# Local Planning Panel

43 Avona Avenue, Glebe

D/2020/1453

# proposal

# materials

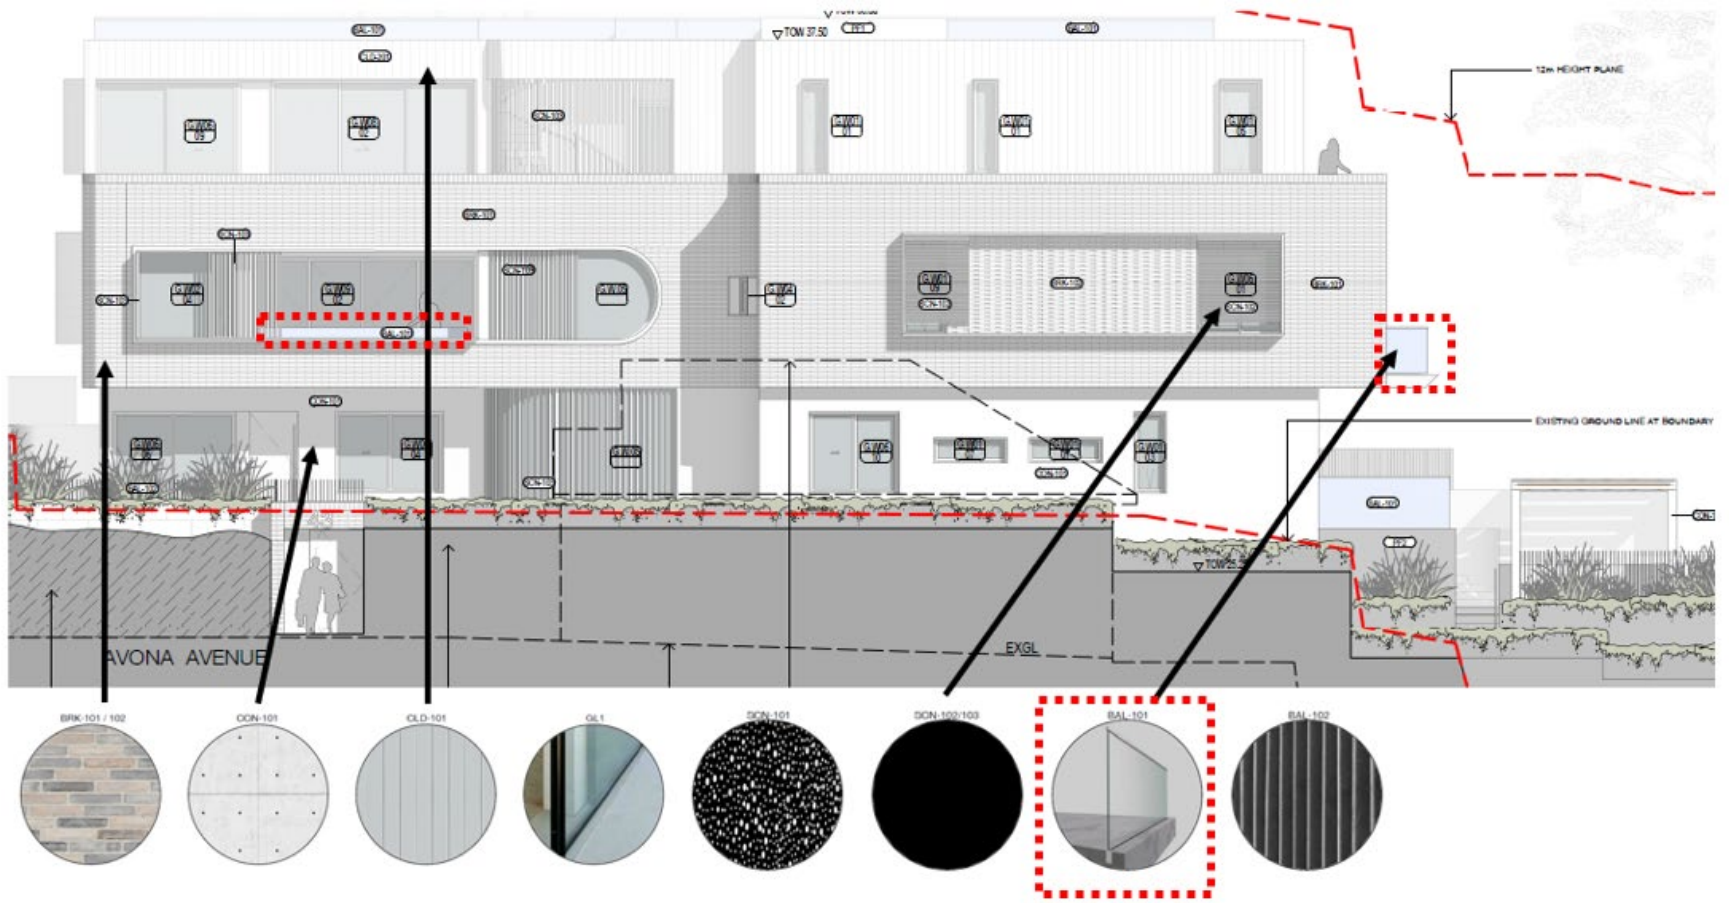
- ground floor to be finished in off form concrete, brick at first floor and metal cladding at second floor
- condition recommended to replace glass balustrades of all balconies with contemporary metal balustrades with vertical balusters

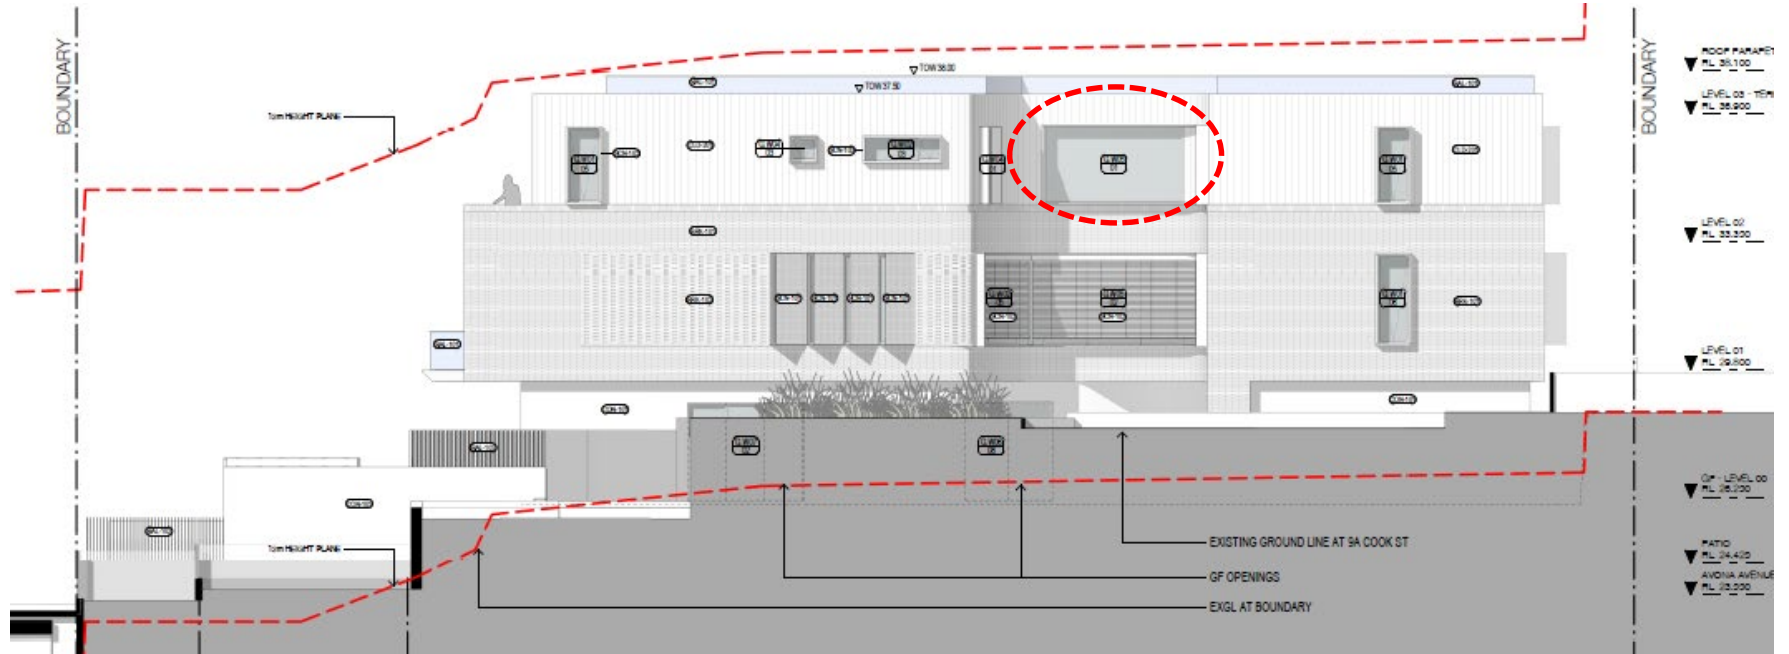
- majority of windows fitted with angled screening to avoid direct sightlines to and from the site
- condition recommended to address potential privacy impacts from window to Level 2 corridor:
  - window to level 2 corridor facing north boundary to be either a highlight window, fitted with louvres or an obscure glazed treatment

remove balcony at level 2

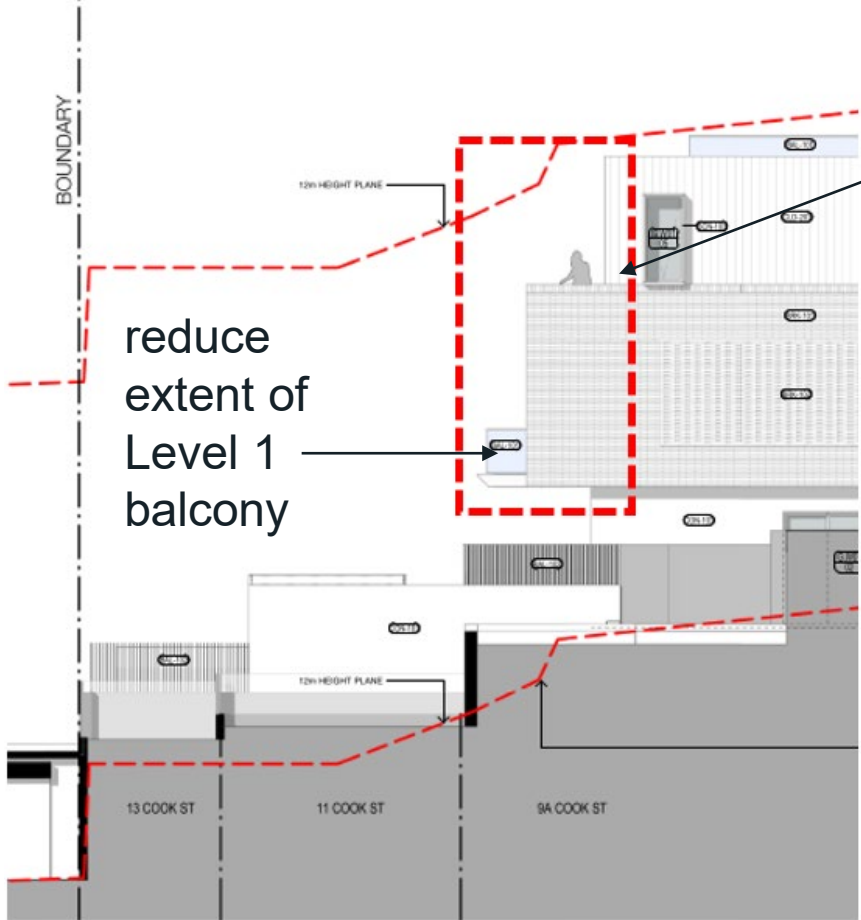
- conditions also recommended to address privacy impacts:
  - removal of roof terrace
  - removal of level 2 east facing balcony (screening not recommended as this will have an adverse impact on views)
  - reduction in size of level 1 east facing balcony so that it does not protrude beyond blade walls

solar access at 9am of the winter solstice (existing and proposed)

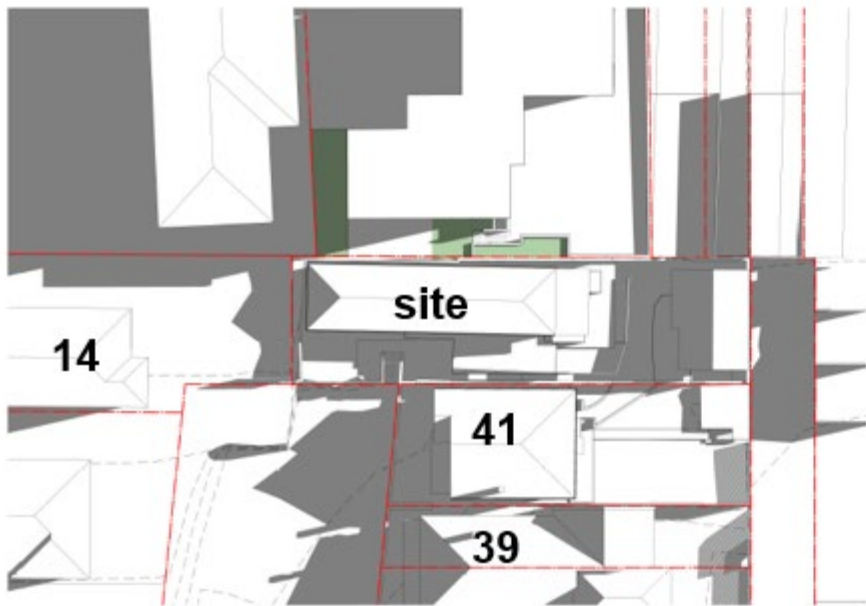
- overshadowing analysis provided in plan at hourly intervals (9am to 3pm at winter solstice), and in elevation at Strathmore Lane elevation (9m to 11am at winter solstice)
- majority of shadows fall across roofs of the terrace row and Avona Avenue roadway
- ground floor of 14 Avona, 39 and 41 Avona retain solar access to private open space and living room windows for at least 2 hours
